**Proposed Temporary Warehouse & Open Storage (Excluding Dangerous Goods) with Ancillary Facilities & Associated Filling of Land for a Period of 3 Years at Lots 1299, 1305 S.A (Part), 1305 S.B RP (Part), 1306 S.A, 1306 S.B (Part), 1307, 1308, 1309 RP, 1310, 1317 RP, 1318, 1360 (Part), 1392 (Part), 1393 (Part), 1394, 1395, 1396, 1397, 1398 S.A & B, 1399 (Part), 1402 (Part), 1403 (Part), 1407, 1408, 1409, 1410, 1411, 1412, 1413, 1414, 1415, 1416, 1417, 1418, 1419, 1421, 1422, 1423, 1424, 1425, 1426, 1427, 1428 (Part), 1429, 1430, 1431, 1433, 1434 (Part), 1435 (Part), 1538 (Part), 1539 (Part) and 1540 in D.D.118 and Adjoining Government Land, Tai Shu Ha Road West, Tai Tong, Yuen Long, N.T.**

In response to the further comments of CE/MN, DSD, we are glad to submit the response to comments in the attachment.

**Temporary Warehouse with Ancillary Facilities for a Period of Years and Associated Filling of Land at Various Lots in D.D. 118, Tai Shu Ha Road West, Yuen Long**

## **DRAINAGE IMPACT ASSESSMENT**

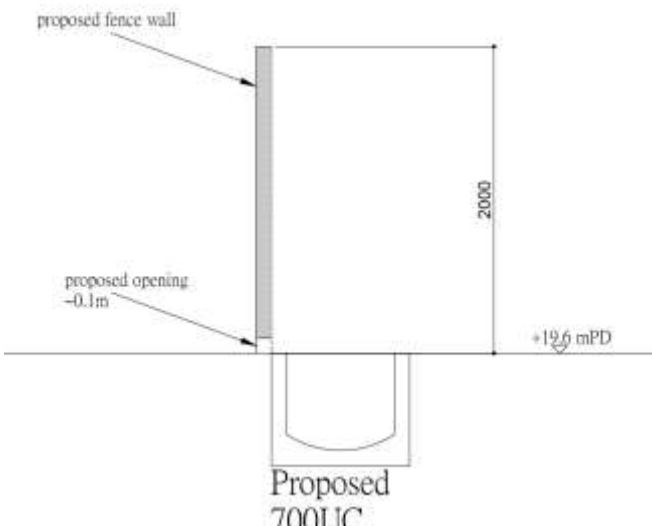
| Comments                                                                                                                         | Responses                                                                                                                                                                                                                                                                                                                                                                                                       |
|----------------------------------------------------------------------------------------------------------------------------------|-----------------------------------------------------------------------------------------------------------------------------------------------------------------------------------------------------------------------------------------------------------------------------------------------------------------------------------------------------------------------------------------------------------------|
| 3. R-to-C item 11 – Please provide details of the fence wall openings in the drawing.                                            | <p>Noted. The section diagrams are provided as follow. The fence wall of about 2mH will be erected along the Site boundary, with about 0.1m above the footing would be reserved as openings to intercept the overland flow passing through the site. In the diagram, the site level of +19.6mPD is for reference only.</p>  |

| Drawing No :<br>FIGURE 2.2a | Revision :<br>0    |

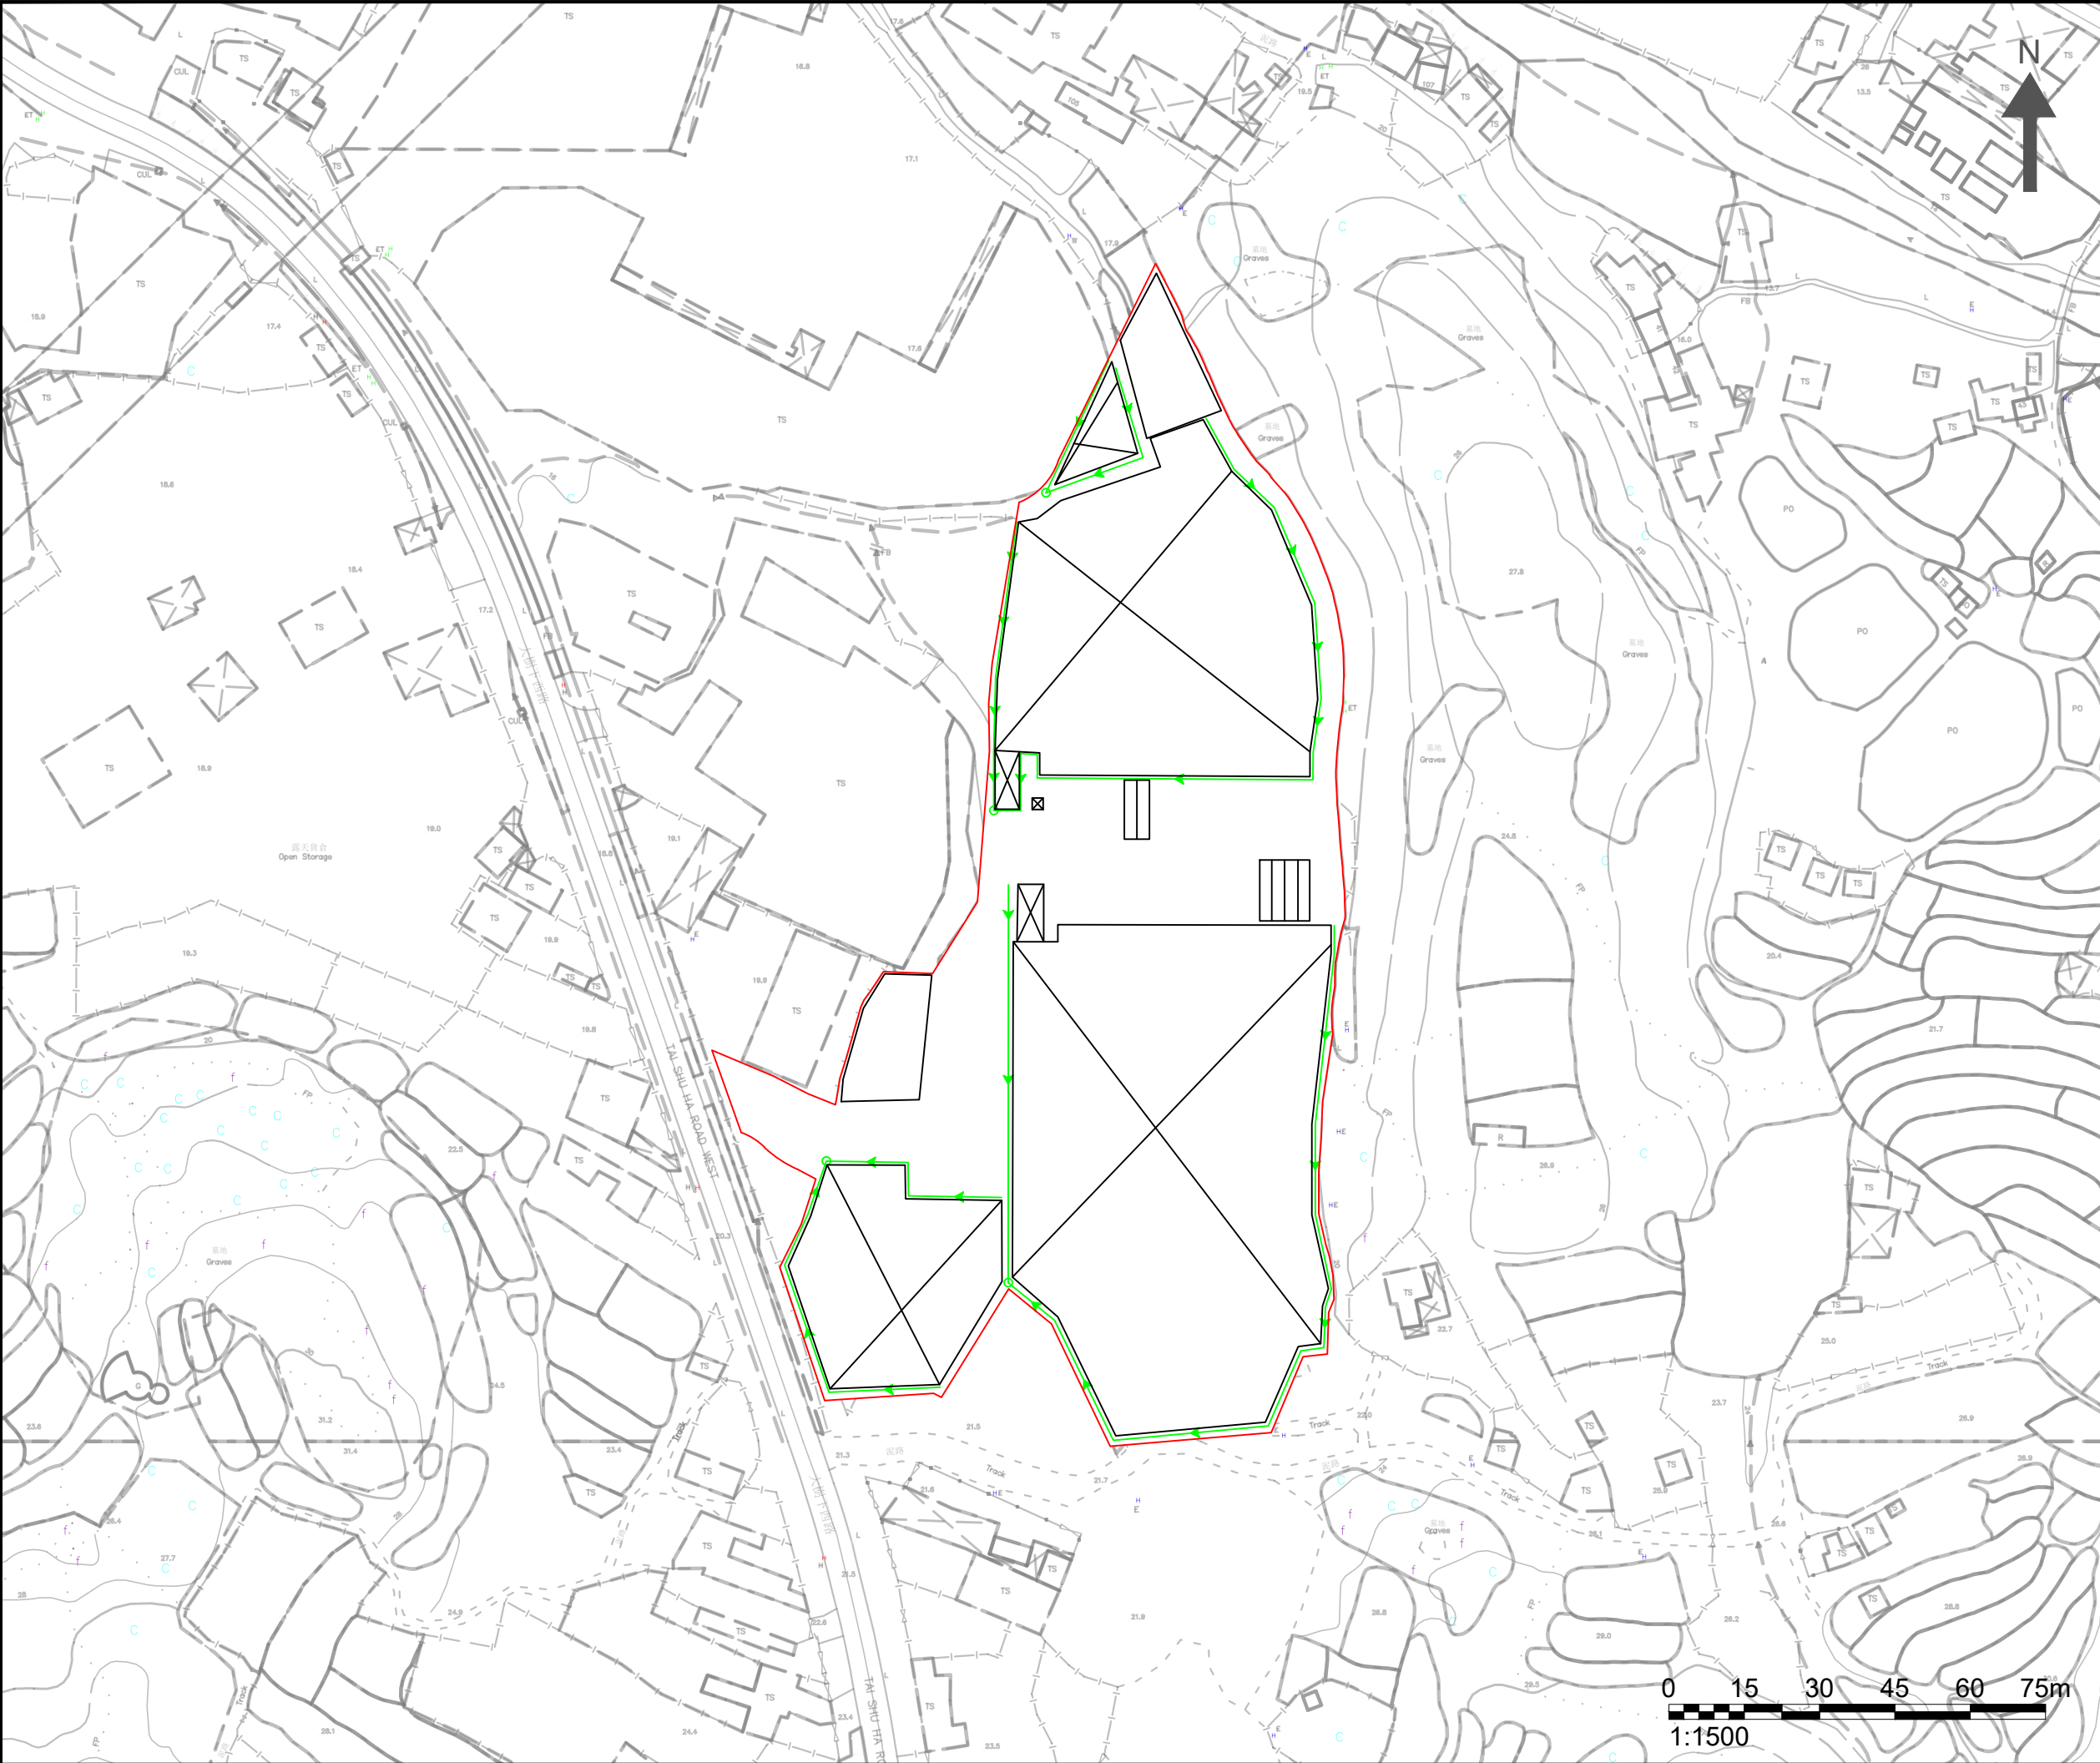
| Comments                                                                                                                         | Responses                                                                                                                                                                                                                                                                                                                                                                                                       |
|----------------------------------------------------------------------------------------------------------------------------------|-----------------------------------------------------------------------------------------------------------------------------------------------------------------------------------------------------------------------------------------------------------------------------------------------------------------------------------------------------------------------------------------------------------------|
| 2. R-to-C item 3 – Please clarify which part of Figure 2.2a is revised for the grating of surface channels.                      | The surface channel with cast iron cover shown in legend of Fig 2.2a.                                                                                                                                                                                                                                                                                                                                           |

| 7. | Figure 2.2a – Catchpit should be provided at the turning point of the proposed u-channel between CP17 and CP18. Please review.                                                                                                                                                                                | Noted, catchpit is added.                                                           |

| 8.  | Figure 2.2a – Please provide details of connection/section of the proposed 900mm underground pipe connecting the proposed sand trap and the existing channel (including the gradient and invert levels of the inlets, outlets and channel). Please also indicate the proposed 900mm underground pipe accordingly.                                                                                                                              | The details of connection is provided in Figure 2.4, the proposed 1200mm underground pipe is indicated in Fig 2.2a.                           |
| 9.  | Figure 2.2a – Please indicate the existing drainage facilities (including its type and size) in the vicinity of the application site for clarity.                                                                                                                                                                                                                                                                                              | Noted, existing box culvert were shown in Figure 2.2a                                                                                         |
| 12. | Figure 2.2a & Appendix C – There is a discrepancy between Figure 2.2a and Appendix C. Figure 2.2a suggests a 700mm u-channel around the site, while Appendix C mentions a 375mm U-channel between CP10 and CP21. Please check and amend accordingly.                                                                                                                                                                                           | Noted, Figure 2.2a and App C are revised and tally.                                                                                           |

**CATCHPIT WITH TRAP  
(SHEET 1 OF 2)**

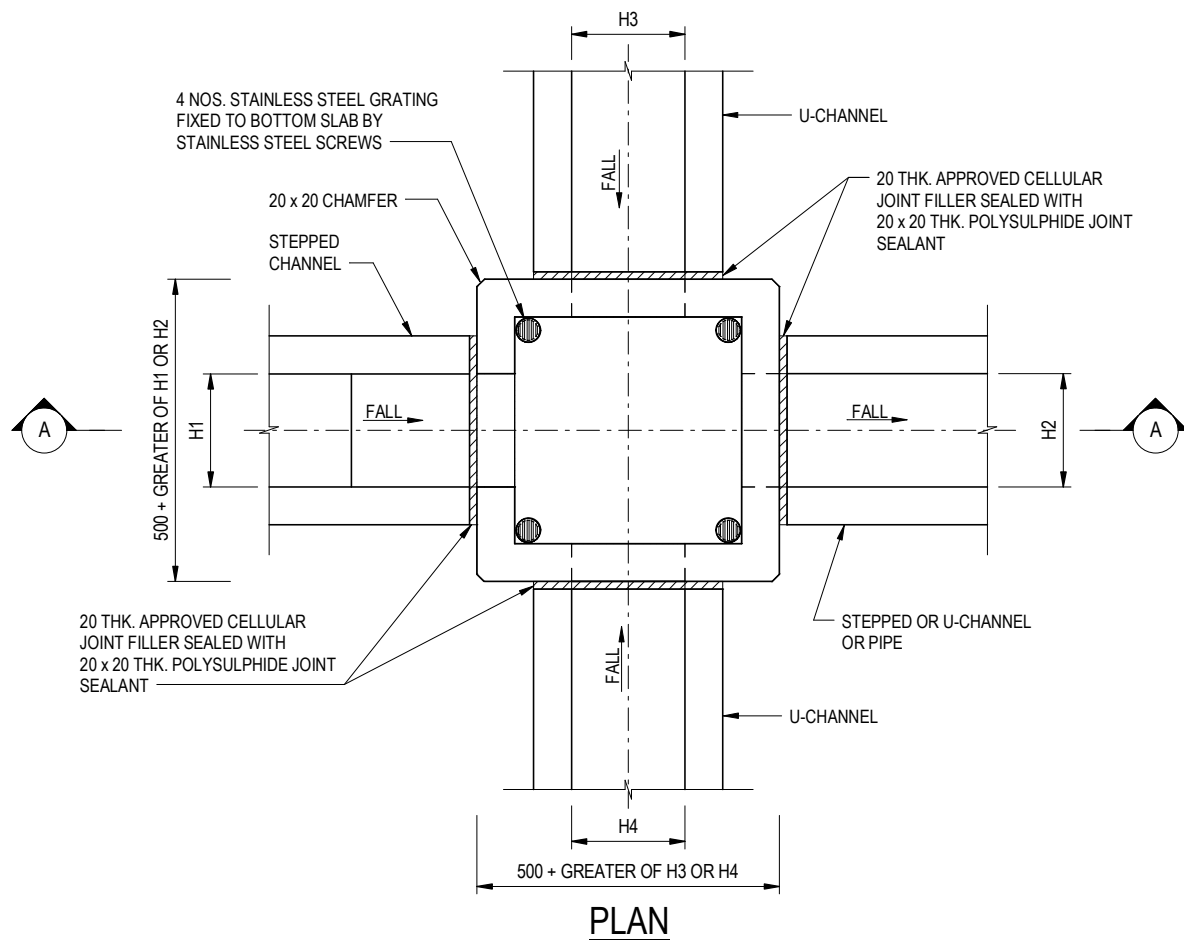
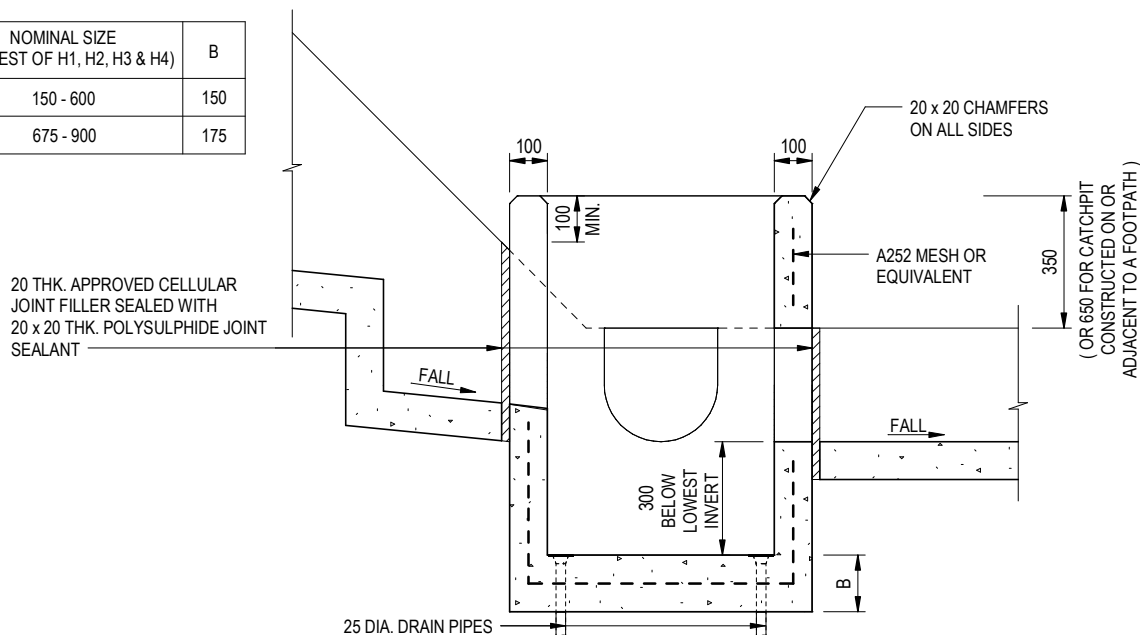
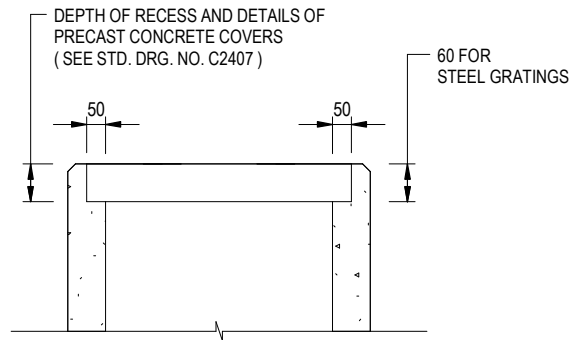
| 4. | R-to-C item 13 – Standard details of the catchpit with sand trap is missing in Appendix E, please review.                                                                                                                                                                                                     | Standard drawing of catchpit with trap is added in App E.                           |
